Twin Pines Minerals, LLC Proposed Heavy Minerals Mine St. George, Charlton County, Georgia

GSI Job No. 5844 Issued: 16 July 2021

RESPONSE TO COMMENTS PROVIDED TO TTL ON APRIL 14, 2021 BY DR. JAMES KENNEDY (KENNEDY, 2021) AS PART OF A TWIN PINES PERMIT COORDINATION DOCUMENT

Figure 4 **Aerial Distribution of Consolidated Black Sands**

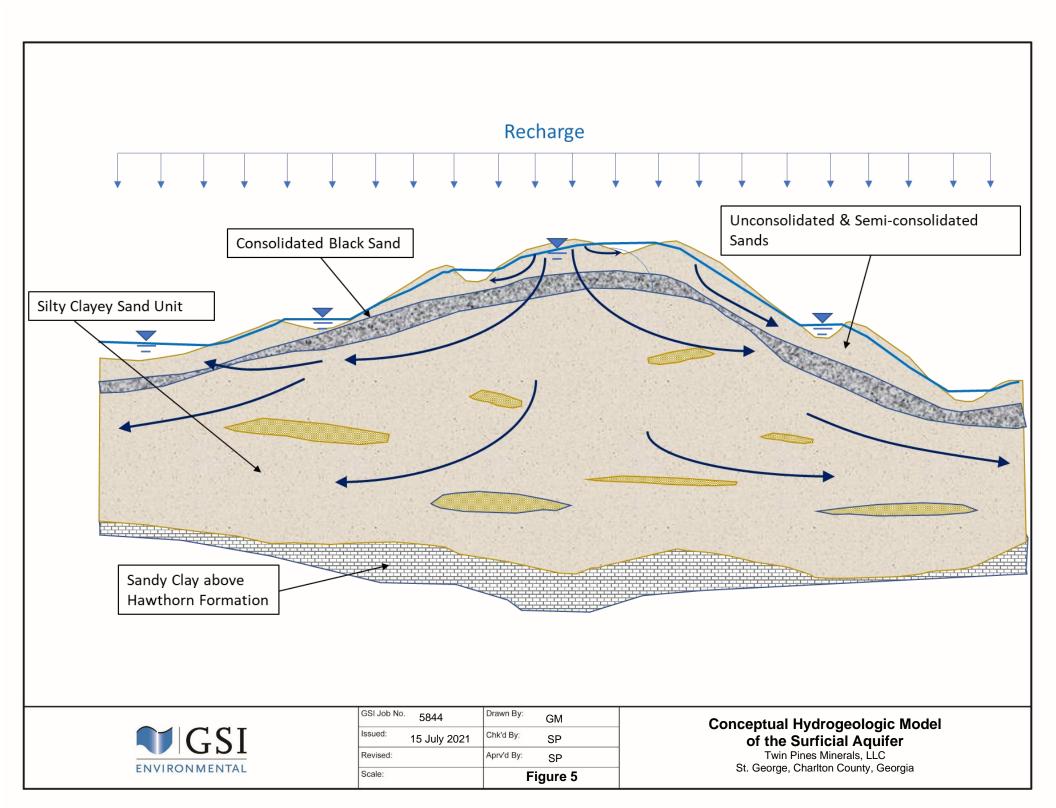
Comment 6b: This comment requests use of data to determine presence or absence of consolidated black sands.

Response: We have mapped the logs with presence and absence of consolidated black sands and used that information to delineate locations where consolidated black sands are present and where they may be absent. This is detailed in GSI (2021). This data indicated that the study area was mostly covered with continuous black sands with small areas where they did not exist, and a small zone showing a transition between where the continuous black sands exist and where they do not.

FIGURE 15

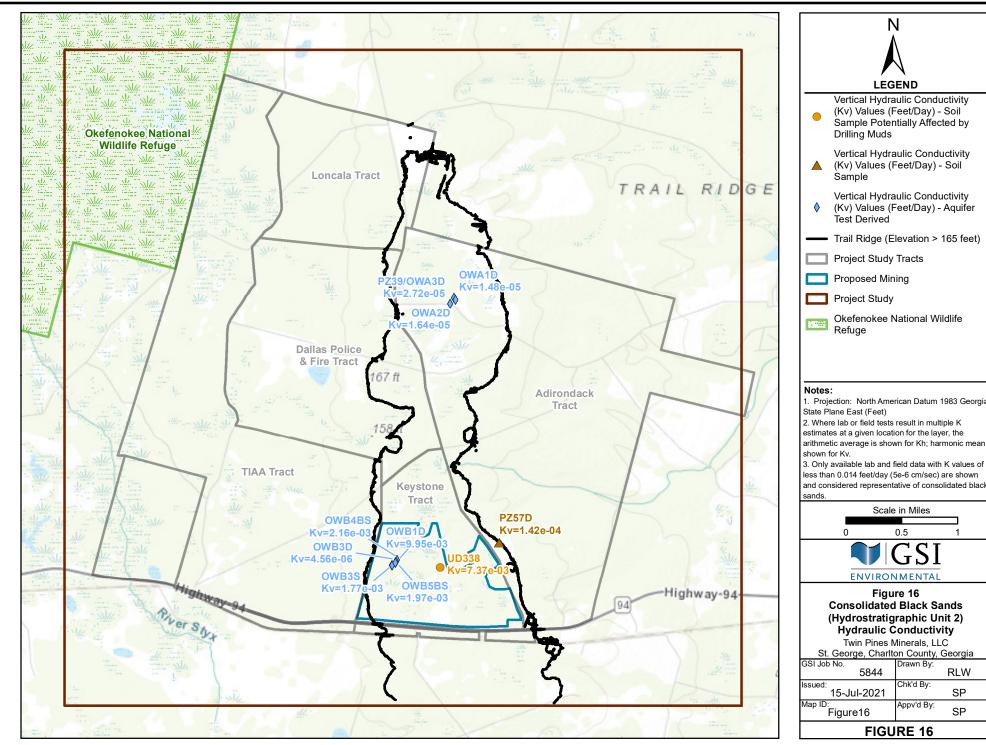
Comment 6c: This comment requests use of hydraulic conductivity values for consolidated black sands that are in line with data from the site. Also, the comment indicates that slug test data that show higher values may not be appropriate for consolidated black sands.

Response: We have mapped the hydraulic conductivity estimates from laboratory and field experiments in GSI (2021). They are low in the range of 10^{-6} to 10^{-8} cm/sec as noted by Dr. Kennedy and that higher values in the range of 5 x 10^{-5} to 10^{-2} cm/sec may indicate composite conductivities with overlying and underlying materials. The model developed in GSI (2021) also uses values in the range of 10^{-6} to 10^{-8} cm/sec for the consolidated black sands.
